Proposed reference equalizer change in Clause 124 (TDECQ/SECQ methodologies).

25th April 2017

P802.3bs SMF ad hoc

Cisco Lab Tx: TDECQ versus equalizer and bandwidth.

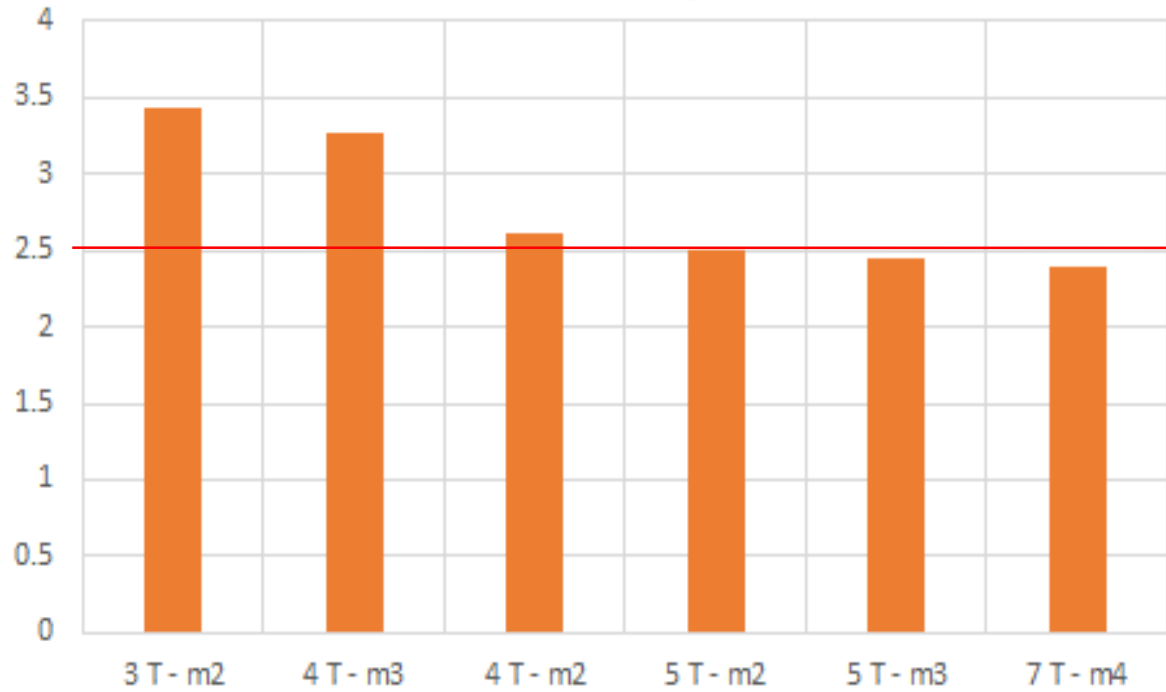
All TDECQ plots show similar trends for varying RX BW (see [mazzini 01a 0317 smf](#) and back-up slide 12). Cisco Lab Tx is not compliant to TDECQ with the 5xT/2 equalizer, but is compliant with a 5xT (same complexity) equalizer.

Longer equalizers give smaller improvements (<0.5dB) in TDECQ.

2.5dB TDECQ seems challenging to be achieved by 53GBaud transmitters.

These results have been also confirmed by other companies by using FlexDCA. When using their homemade methods to calculate TDECQ, some differences with respect FlexDCA were observed, especially for low BW/short equalizer conditions.

Cisco Lab Tx: TDECQ versus equalizer type and length

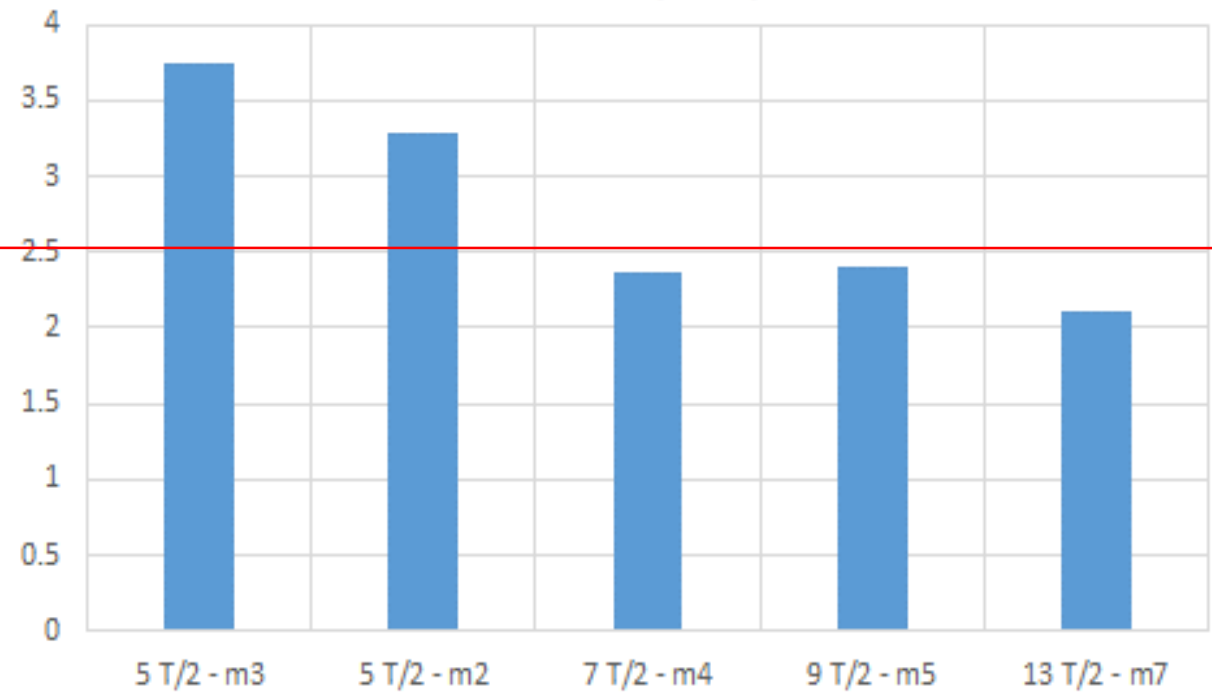
Cisco Lab Tx not compliant to TDECQ considering $5 \times T/2$ equalizer, but is compliant for a $5 \times T$ equalizer, which is same complexity for DSP developers.

Longer equalizers than $5 \times T$ give smaller improvements ($< 0.5\text{dB}$) on TDECQ.

124.8.5 Transmitter and dispersion eye closure for PAM4 (TDECQ)

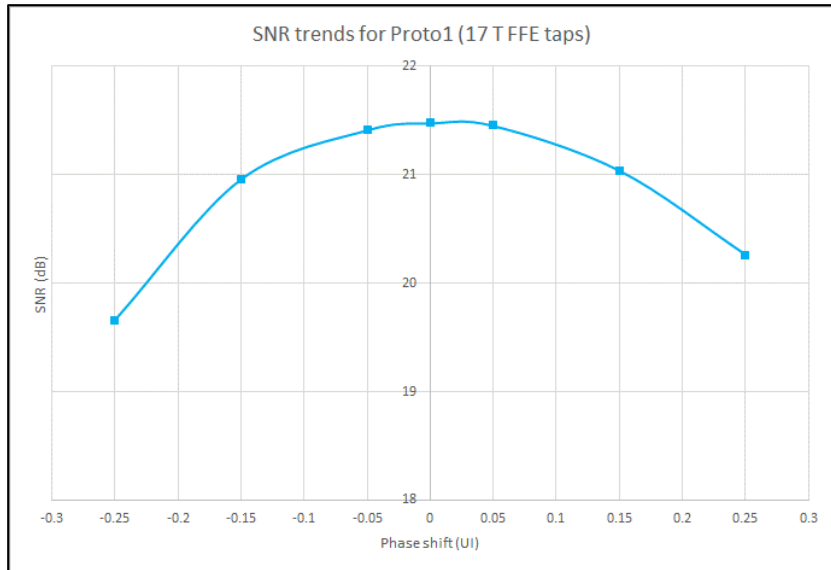
Into 124.8.5, change:

The TDECQ of each lane shall be within the limits given in Table 124–6 if measured using the methods specified in 121.8.5.1, 121.8.5.2, and 121.8.5.3 **using a reference equalizer as described in 121.8.5.4**, with the following exceptions: — The signaling rate of the test pattern generator is as given in Table 124–6. — The combination of the O/E converter and the oscilloscope has a fourth-order Bessel-Thomson filter response with a bandwidth of 38.68 GHz.

The TDECQ of each lane shall be within the limits given in Table 124–6 if measured using the methods specified in 121.8.5.1, 121.8.5.2, and 121.8.5.3 with the following exceptions: — The signaling rate of the test pattern generator is as given in Table 124–6. — The combination of the O/E converter and the oscilloscope has a fourth-order Bessel-Thomson filter response with a bandwidth of 38.68 GHz. — **The reference equalizer is a 5 tap, T spaced, feed-forward equalizer (FFE), where T is the symbol period.**

NOTE—This reference equalizer is part of the TDECQ test and does not imply any particular receiver equalizer implementation.

Recap of measured BERs with TIA assembly and various equalizers.

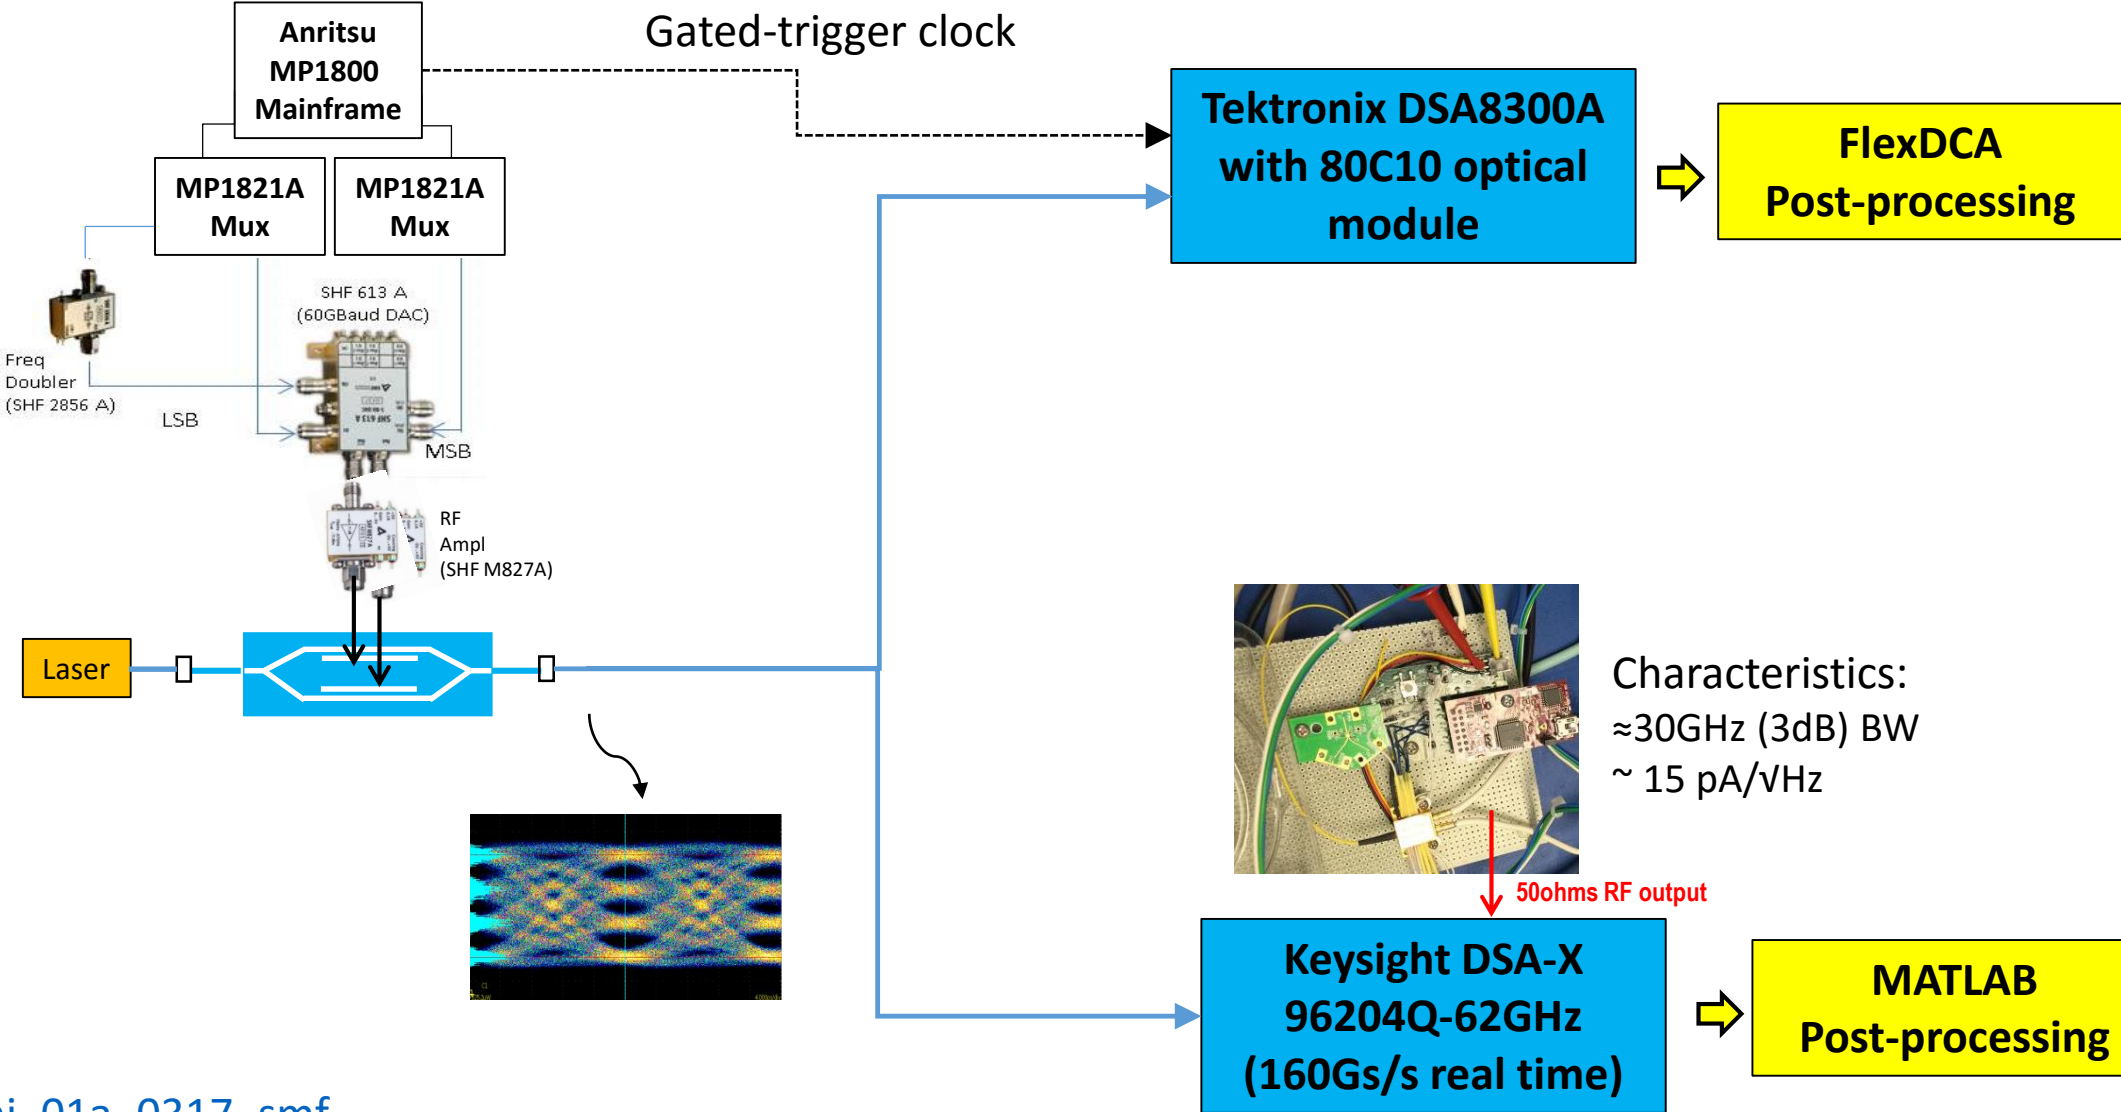
Left chart showing penalty versus long equalizer chain, as well indicates the equivalent T-spaced receiver that makes sensitivity as the 5 taps T/2 equalizer.

- T-spaced equalizer provides close to 1dB OMA_{outer} penalty w/respect T/2 cases. **Not significant improvement increasing the T-spaced equalizer length from 7 to 9 or 11 taps**, 5 taps close to floor.
- 5T/2 is almost equivalent to 9 taps T in terms of sensitivity.

Depending on the different criterion to optimize the FFE taps, results can converge more towards long equalizer chain or not (we're also investigating sensitivity behavior versus criterion).

The usage of longer equalizer chain seems help normalizing results variability across companies, so reducing risks and debug time.
